D. Comments on the Statistical Treatment and Accuracy of the D&M Results.

Figure 1. CERC and DGM Relationship of Wind Stress Coefficients to Wind Speeds along the Prime Vector of a Probable Maximum Hurricane (PMH).

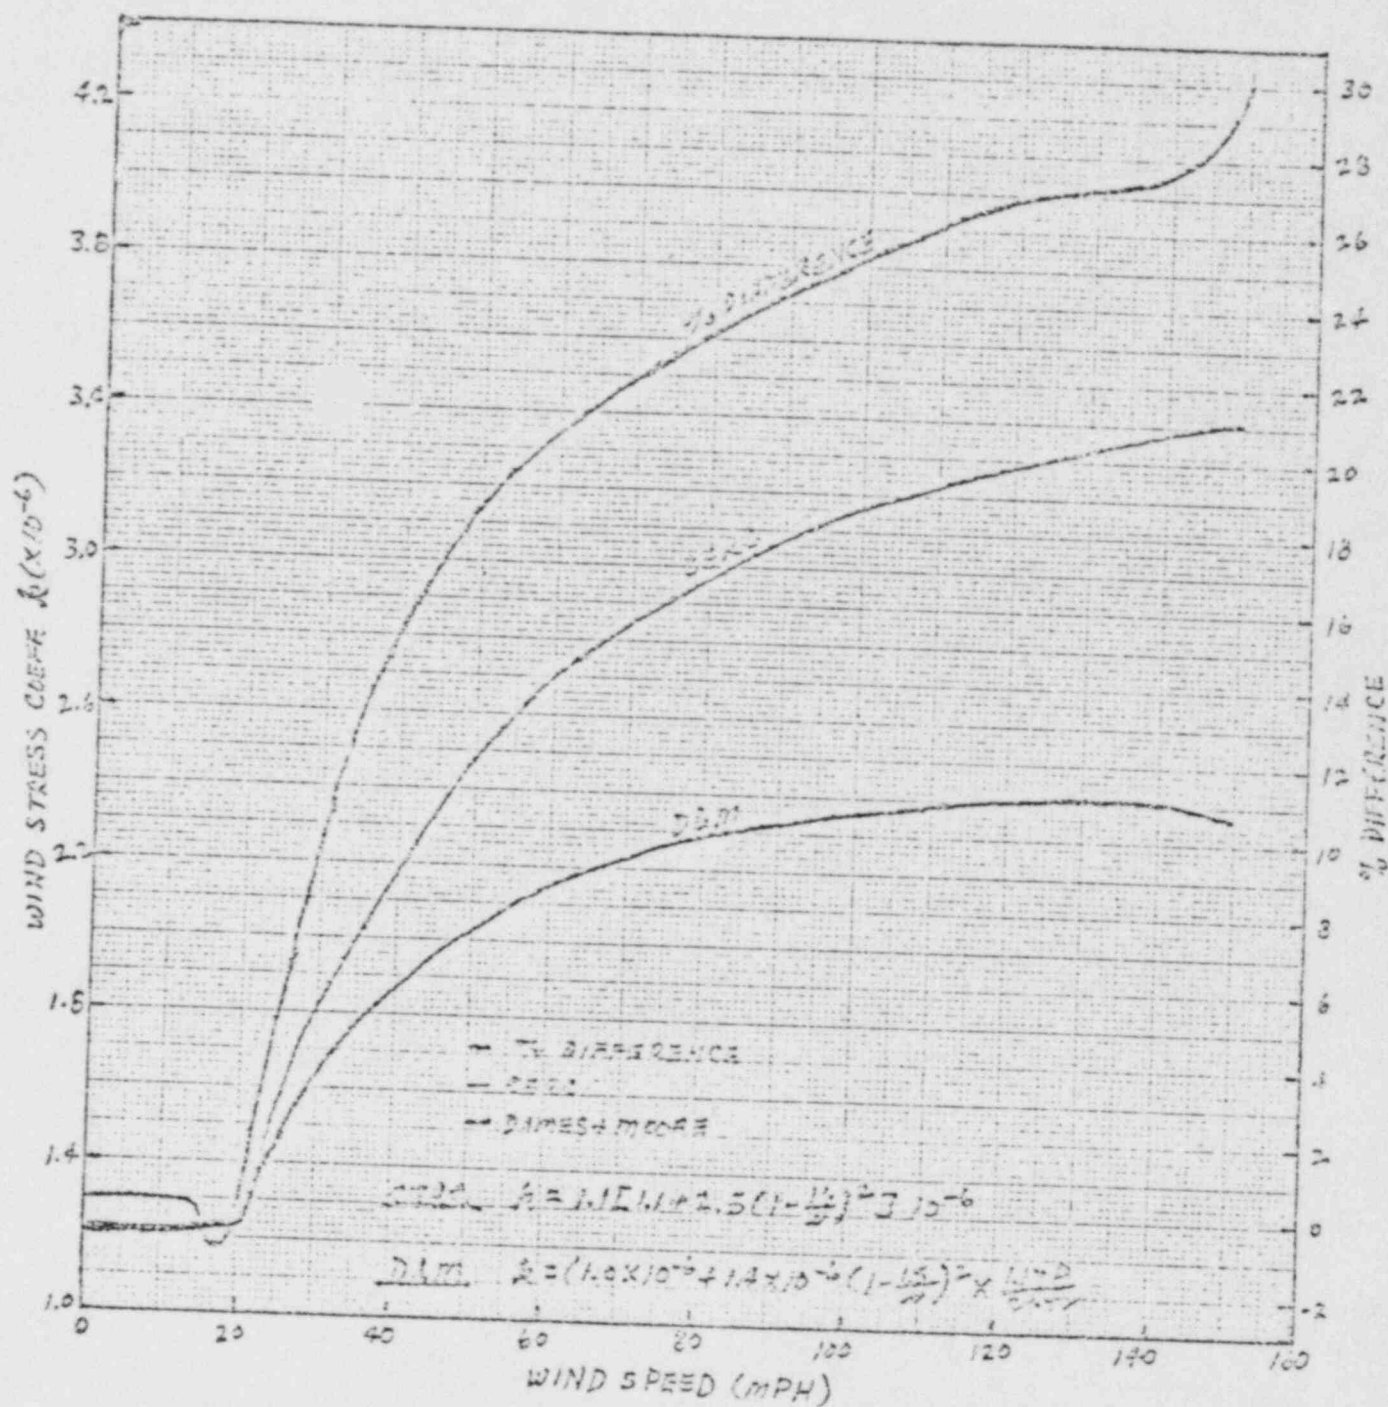
3. To check on the validity of the D&M wind stress equation using their coefficients and their pressure-dependent factor and in order to compare it to CERC's wind stress equation, using the same bottom friction factor, the following test was applied. Using the parameters of the probable maximum hurricane, PMH, ( $P_0 = 26.7$  in. of Hg.,  $P_n = 31.25$  in. Hg.,  $R = 24$  n. mi.,  $V_t = 20$  knots, and  $U_{max} = 149.9$  mph) wind speeds and pressures were calculated along the hurricane's prime vector for increasing integer distance intervals of the ratio,  $r/R$ . Utilizing these data, both the D&M and CERC wind stress equations were solved and respective values of wind stress coefficients were tabulated in Table 1. To illustrate graphically the differences of both the CERC with D&M wind stress coefficients with increasing wind speeds, a plot was prepared (Figure 1). The percent difference between the CERC and the D&M wind stress coefficients were similarly calculated for each wind speed interval and plotted on the same graph. Examination of these graphs indicates that both the CERC and D&M wind stress coefficients have approximately the same initial values up to wind speeds of 20 mph. Beyond wind speeds of 20 mph, the CERC calculated wind stress coefficient increases at a greater rate than the D&M coefficient; at 30 mph, the difference increases to 9%, at 50 mph to 13.5%, and at 100 mph to 25.2%. Also apparent from this graph is that the pressure factor introduced in the D&M wind stress calculation, cannot possibly

compensate for increased stress due to stronger winds as the region of maximum winds is approached. As shown, the speeds between 80-90 mph the D&M wind stress coefficient approaches a plateau value and retains the same or an even lower value in the vicinity of maximum winds (149.9 mph). This does not appear to be consistent with previous investigations since wind speed is a more important factor than atmospheric pressure in determining the wind stress.
